**From:** peter li  
**Sent:** 12/05/2025 7:53:32 PM  
**To:** Council Northernbeaches Mailbox  
**Subject:** TRIMMED: DA2025/0272 - 6 Lockhart Place, Belrose - Objection Letter  
**Attachments:** Formal Planning Objection to DA2025\_0272 - 58 Neridah Ave Belrose.pdf;

**RE: DA2025/0272 - 6 Lockhart Place, Belrose NSW 2085**  
**Formal Planning Objection to DA2025/0272**

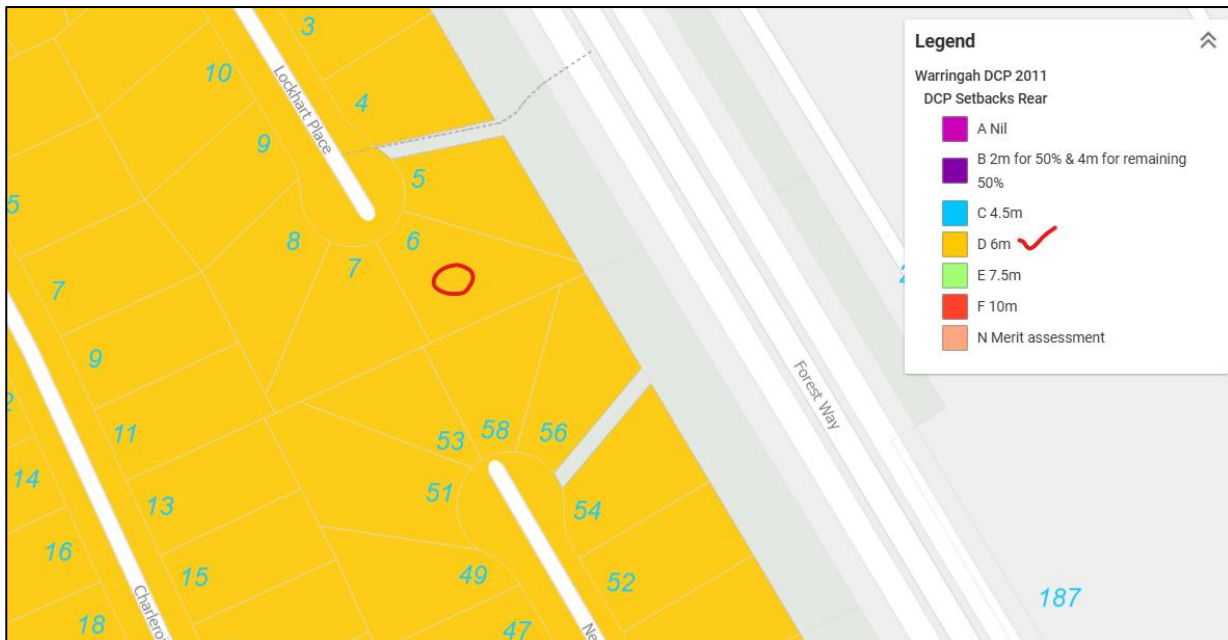
The proposed rear setback of 4.525 metres falls significantly short of the 6 - 8 metre setbacks typical of the Belrose area. This reduced setback increases the building footprint at the rear, limits landscaping, and heightens privacy and overshadowing impacts.

The construction of a two-storey building in such close proximity would significantly compound the loss of sunlight to private open space, particularly in winter months, further undermining residential amenity and usability of rear yard areas.

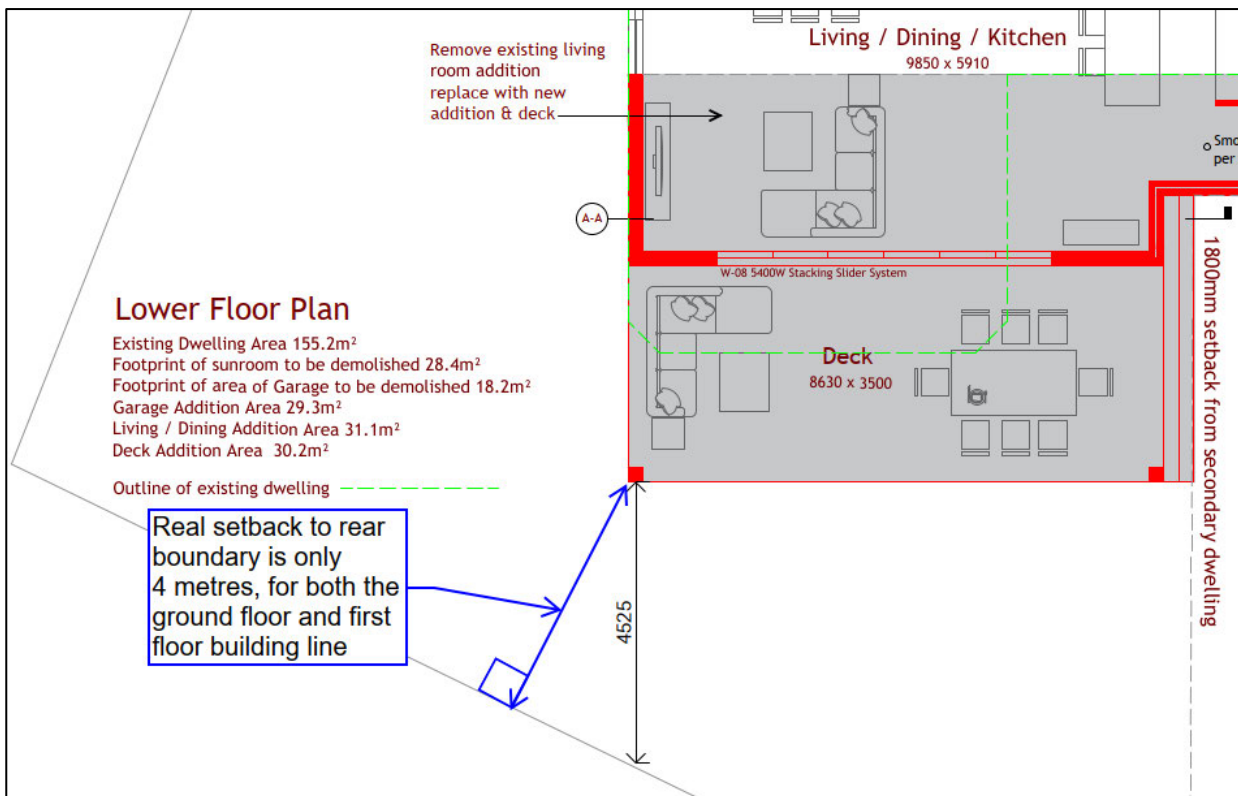
A rear setback of 6 metres applies to the development site as per the rear setback map below from Council's DCP website.

As per the image below, the provided setback from the proposed house to the rear boundary is only about 4 metres on the perpendicular, which is well short of the required 6 metre setback. The first floor bedrooms are also at this 4 metre setback, providing bulk and privacy issues for the southern neighbours at 53 and 58 Neridah Ave.

Council cannot approve this construction footprint. The house needs to be redesigned with a significant reduction in the bulk of the building, including ground and first floors.

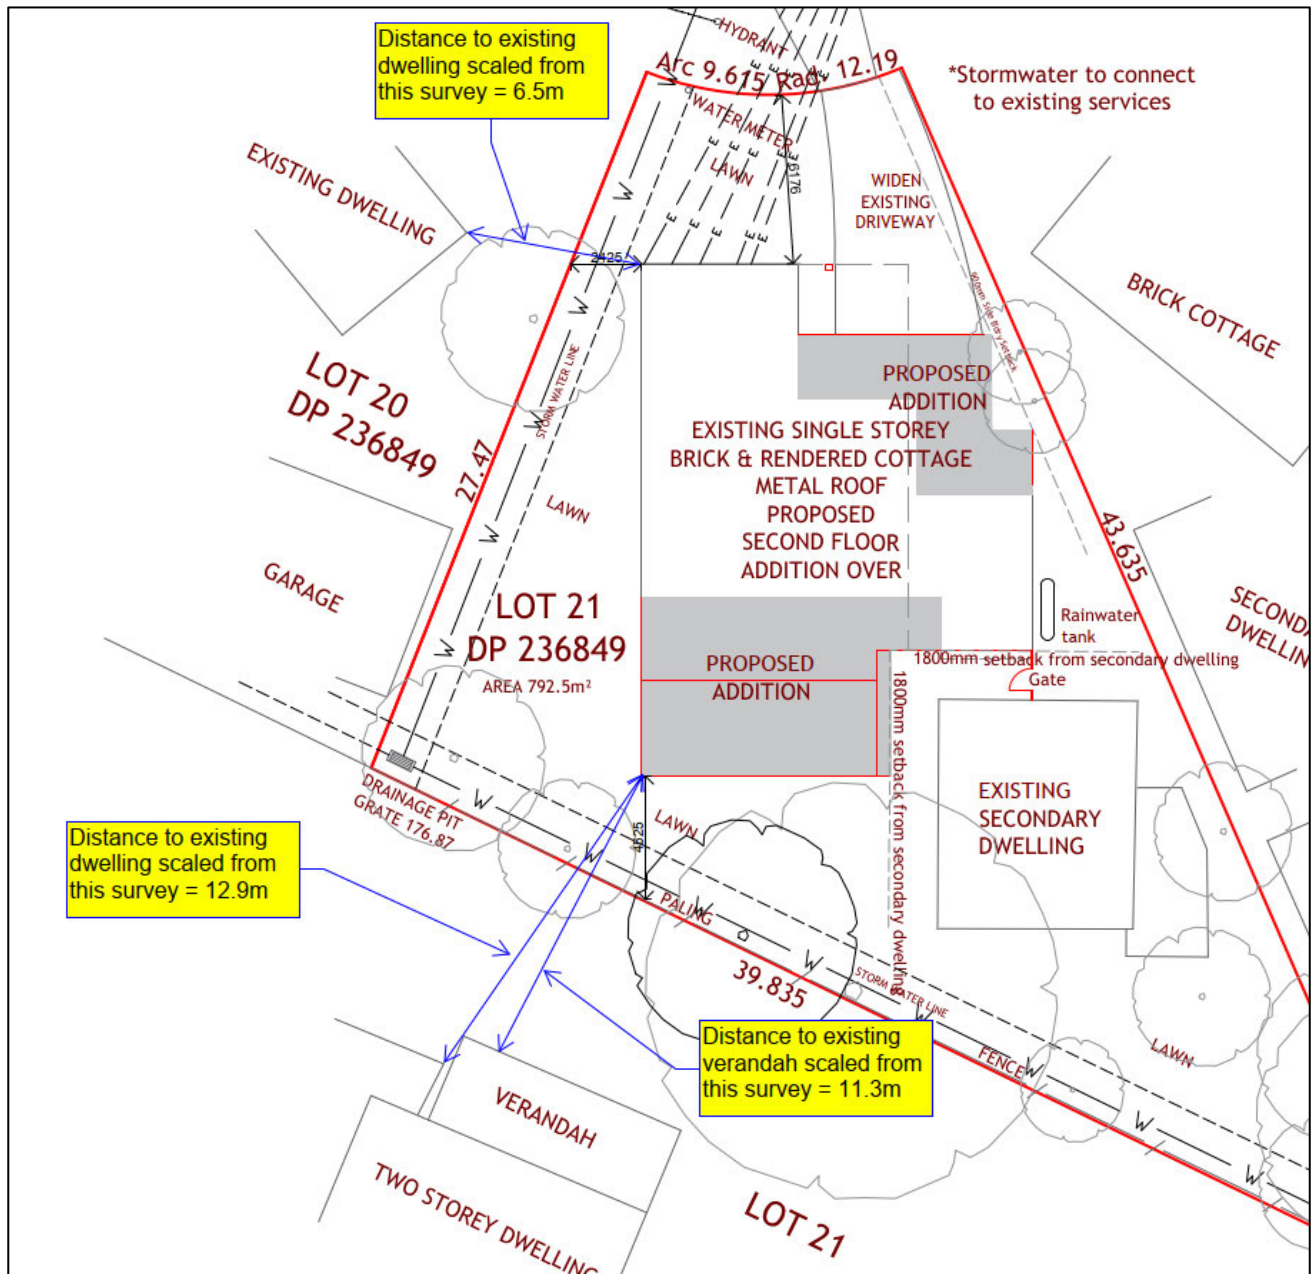
The diagrams submitted for March, June, and December show significant overshadowing of neighbouring properties throughout the key periods. Specifically, the diagrams for June 21st (images 4, 5, and 6) indicate that adjoining properties to the south and southwest, receive little to no direct sunlight from 9am through to 3pm. This suggests a direct breach of the minimum solar access requirement.

- Fail to identify or label the adjoining properties that are impacted;
- Do not provide a site overlay with boundary lines to confirm which areas constitute PPOS;
- Show no modelling of the substantial **existing 15-metre Melaleuca tree** already located in my rear yard, which contributes to year-round shading;
- Appear visually inconsistent and potentially distorted, with soft shadow transitions and shape warping atypical of compliant solar modelling practices.

Given these deficiencies, it is likely that actual overshadowing has been materially understated. Council should not rely on the current shadow analysis to determine compliance and must request an updated, geolocated shadow impact assessment with:

- Property boundaries clearly marked;
- Existing vegetation (e.g. the Melaleuca tree) factored in;
- A clear overlay showing which parts of adjoining lots are affected.

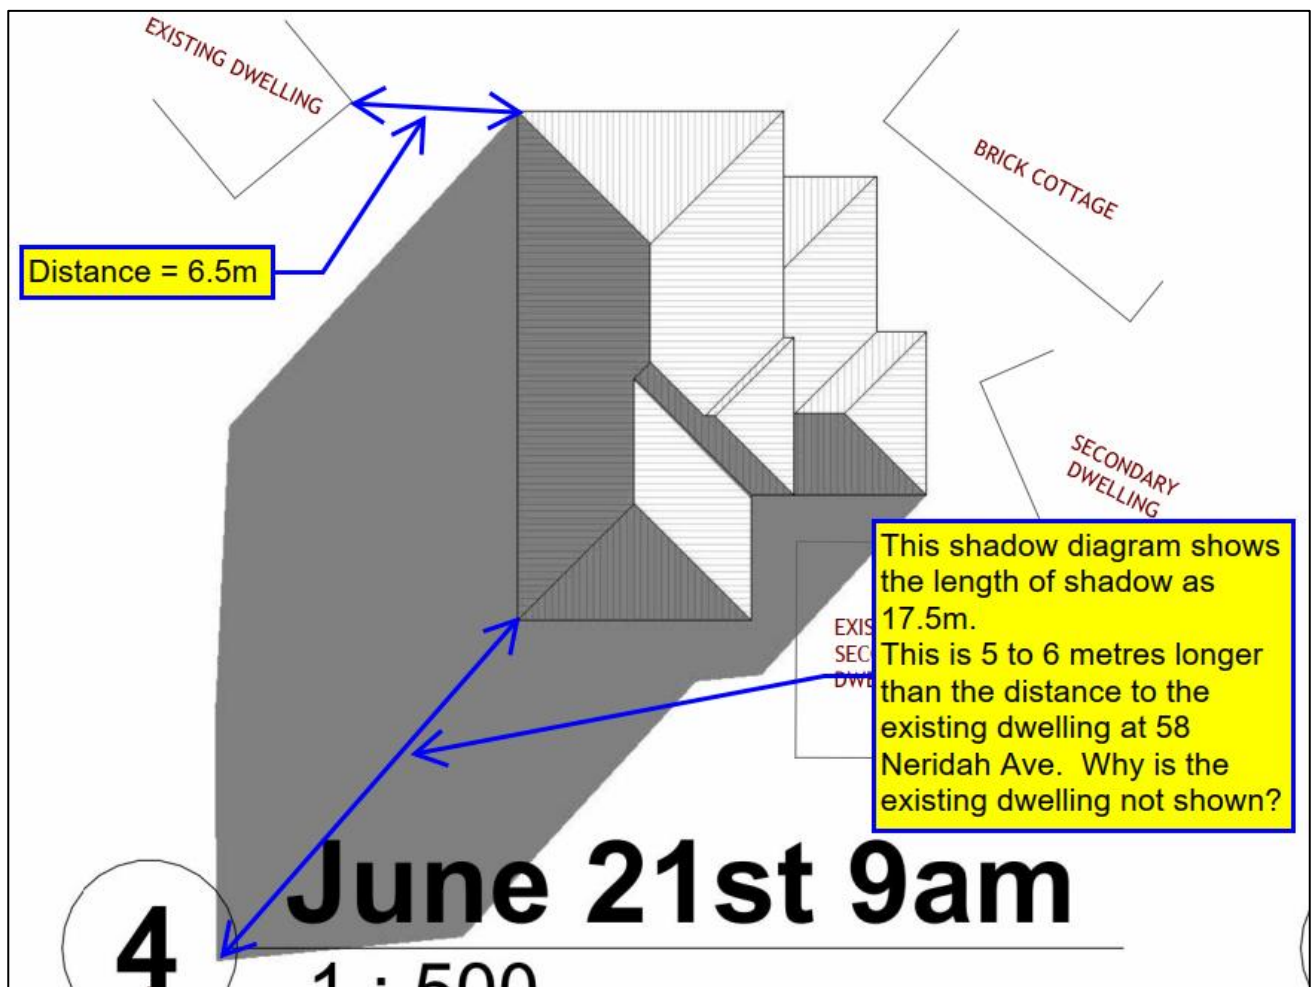
From the site/survey plan below, we can see that the distance from the rear of the proposed dwelling to the existing dwelling on Lot 21 (58 Neridah Ave) is about 11 to 13 metres. The distance from the front of the house to the existing dwelling on Lot 20 is about 6.5 metres.

We can clearly see the existing dwelling on Lot 21 (58 Neridah Ave) is omitted from the shadow diagram provided by AJH Design (refer image below).

In this regard the shadow diagrams are unreliable and actively misleading. In reality, the proposed building will result in extensive shadowing of the existing house and verandah at 58 Neridah Ave.

The shadow diagrams need to be redone once the proposed house is re-designed with significant reduction in bulk and increased rear setback.
